Subject: Response to Request for Additional Information
Southeast County Landfill, Hillsborough County
Capacity Expansion Section 8
Certification of Construction Completion
Permit No. 35453-009-SC
Jones Edmunds Project No. 08449-020-01

Following our meeting on June 14, 2006 to discuss the Section 8 Certification of Construction Completion Report (Report), you had requested some additional information to be submitted to our office to assist you with completion your approval of the Report. The additional information that you requested is listed below.

ATTACHMENT 13
Revised Record Drawing No. 9

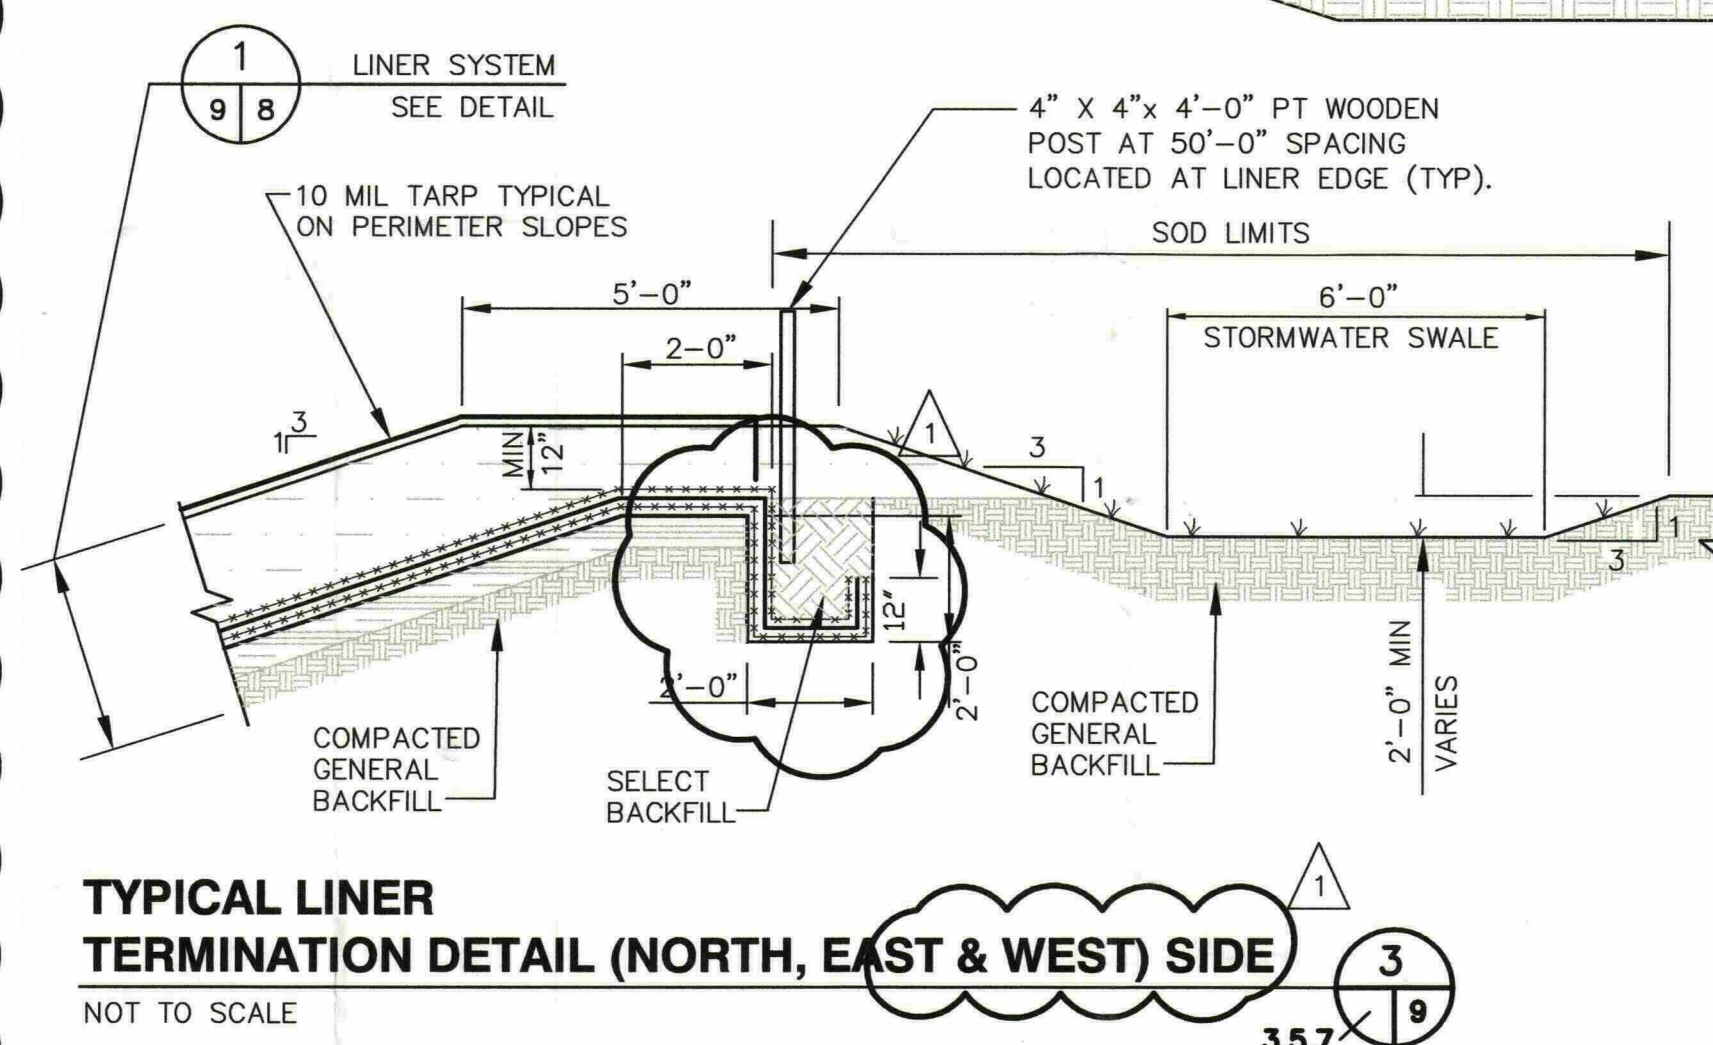
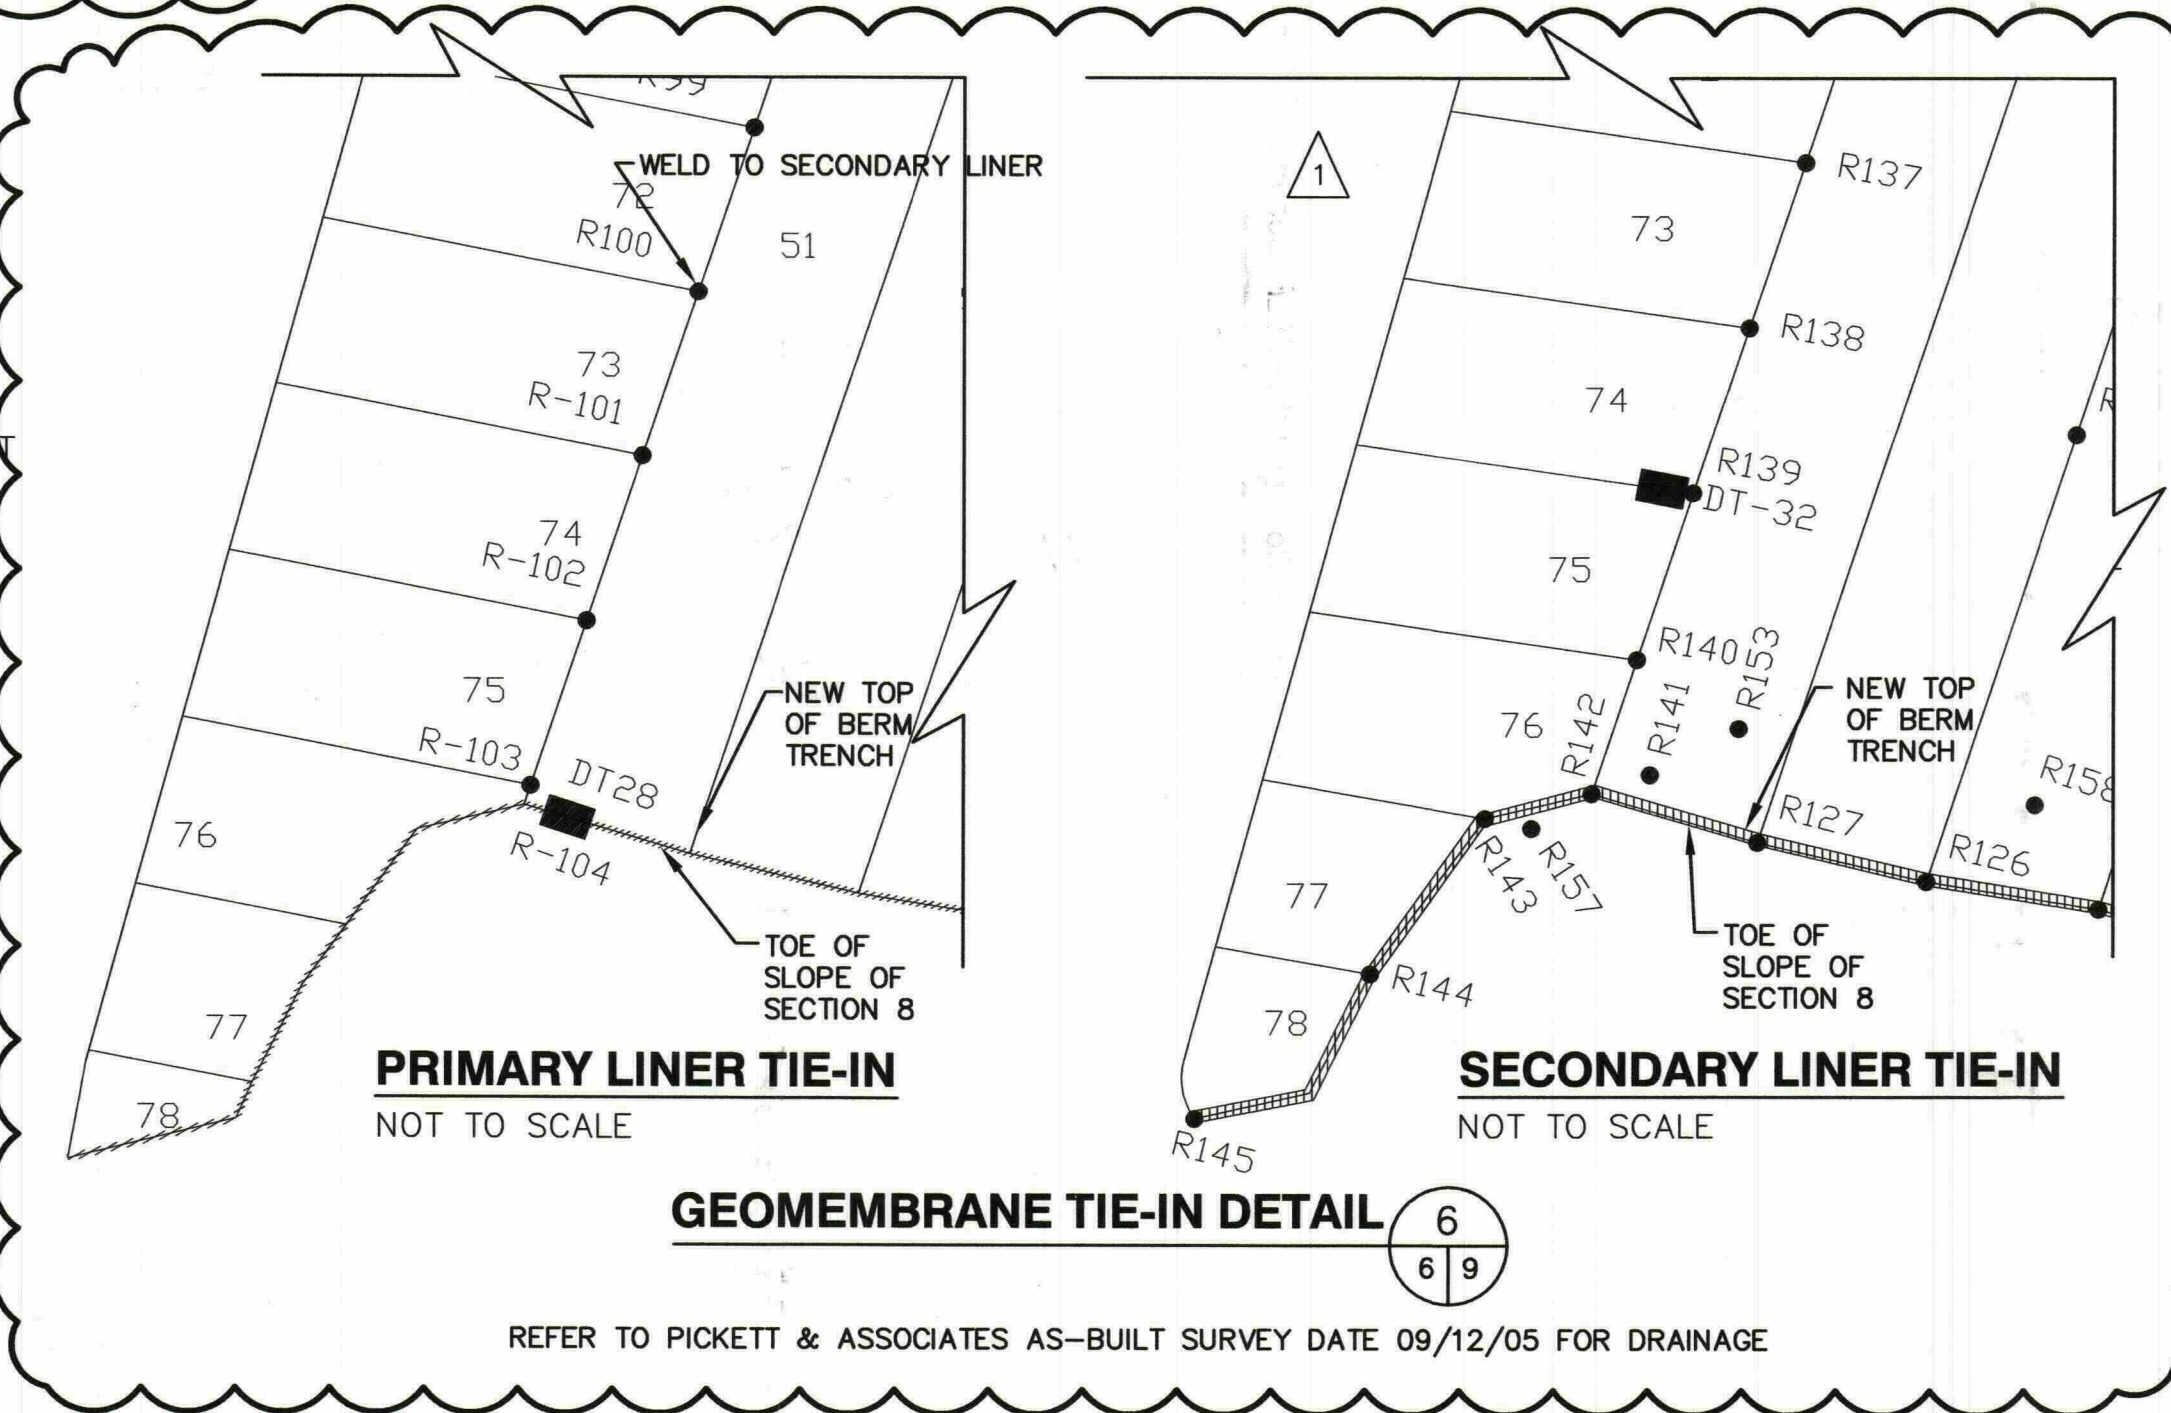
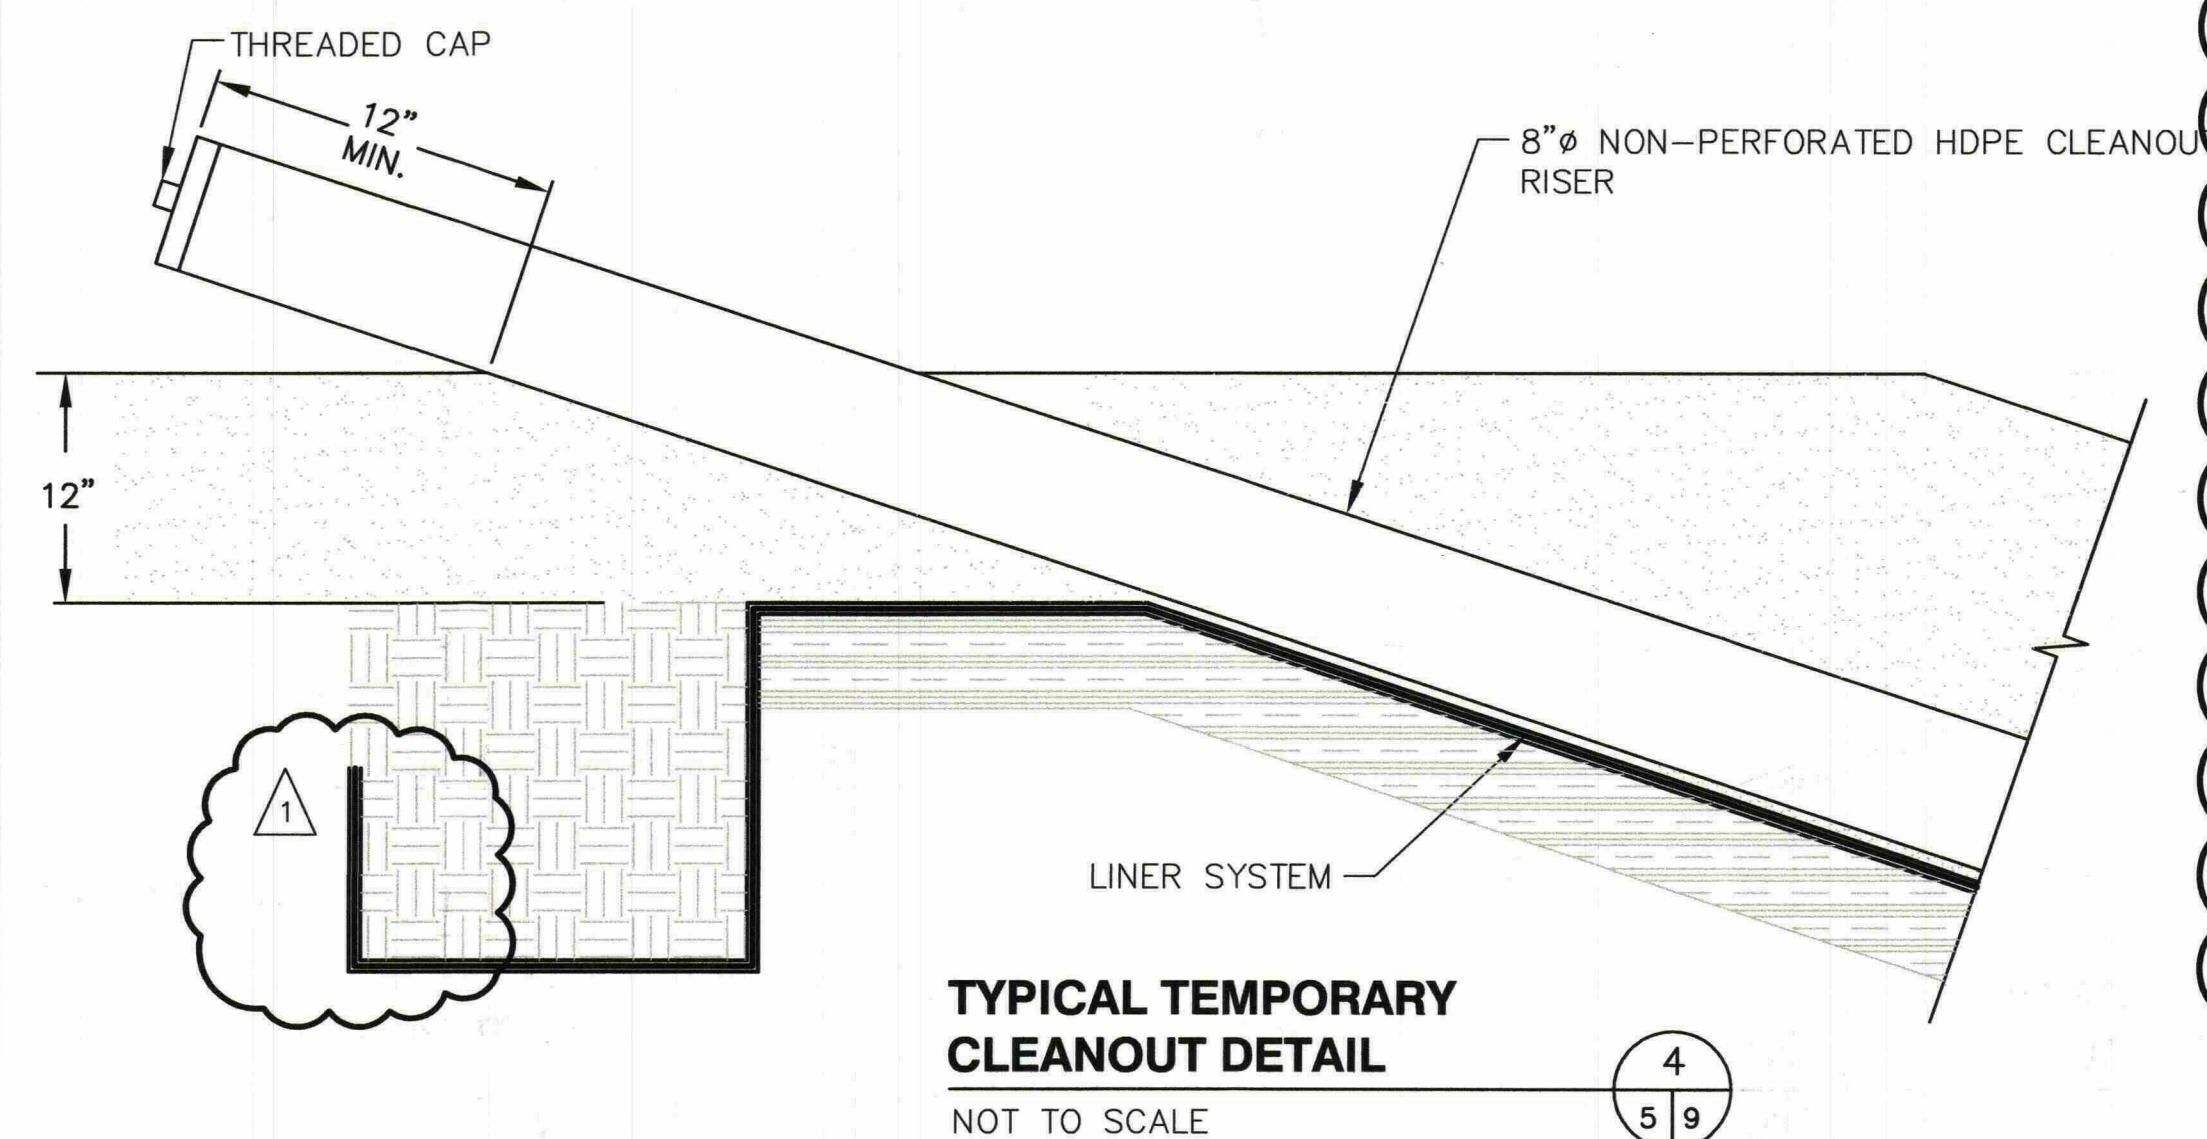
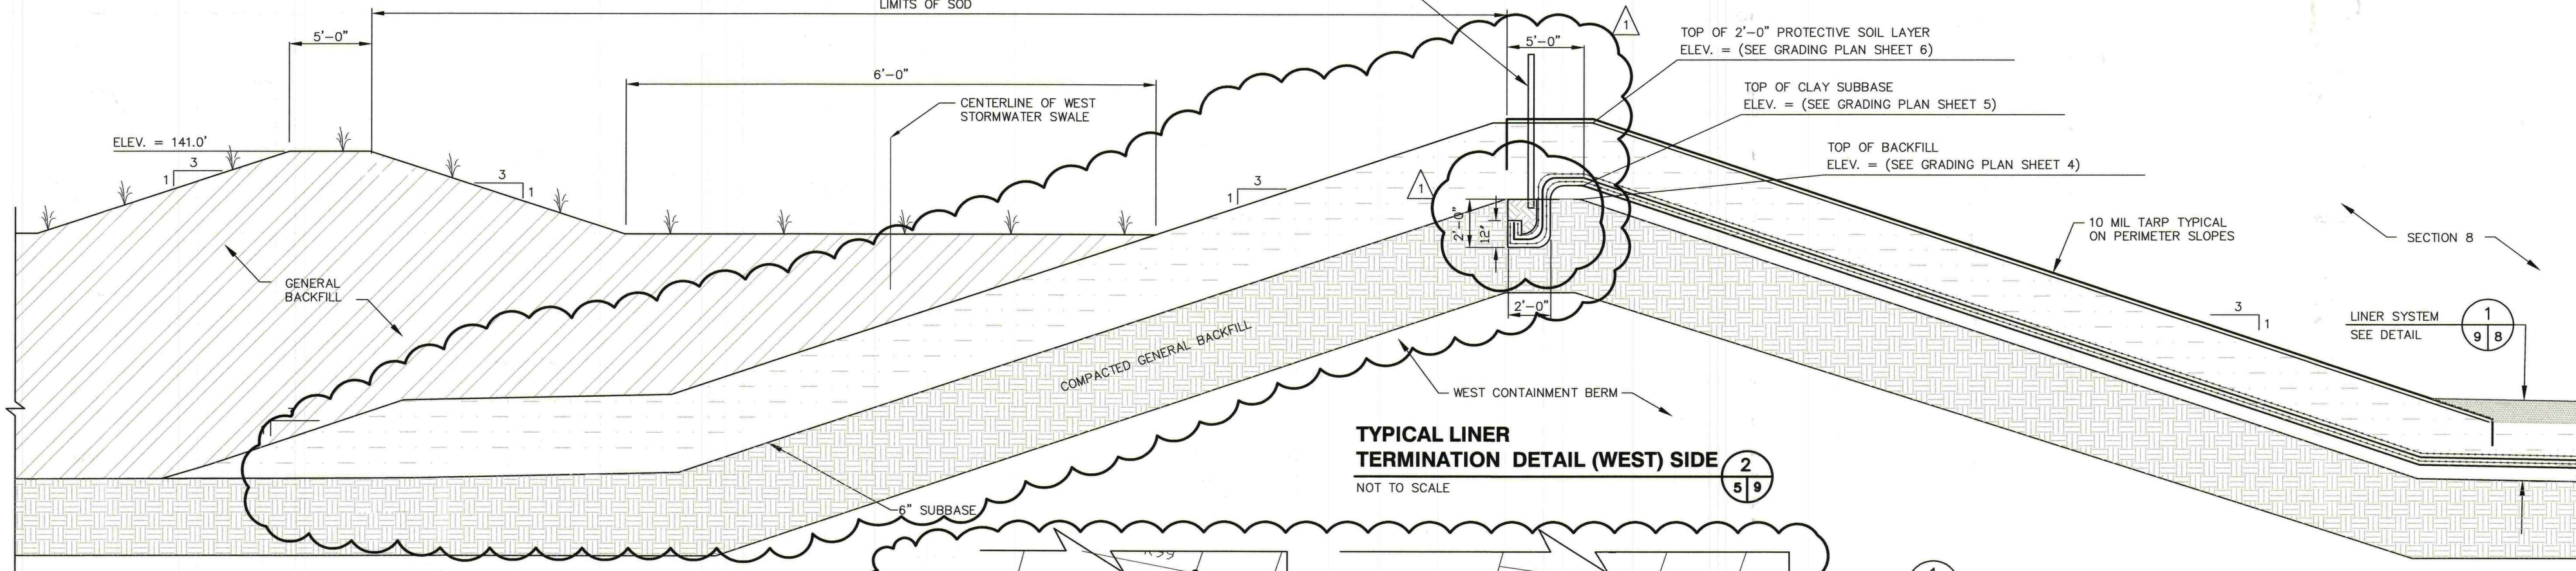
Comment 19) Please resubmit Drawing No. 9, Detail 6 with drainage information from the Pickett Survey .

Response 19: Provided in Attachment 13 is a revised Drawing No. 9.
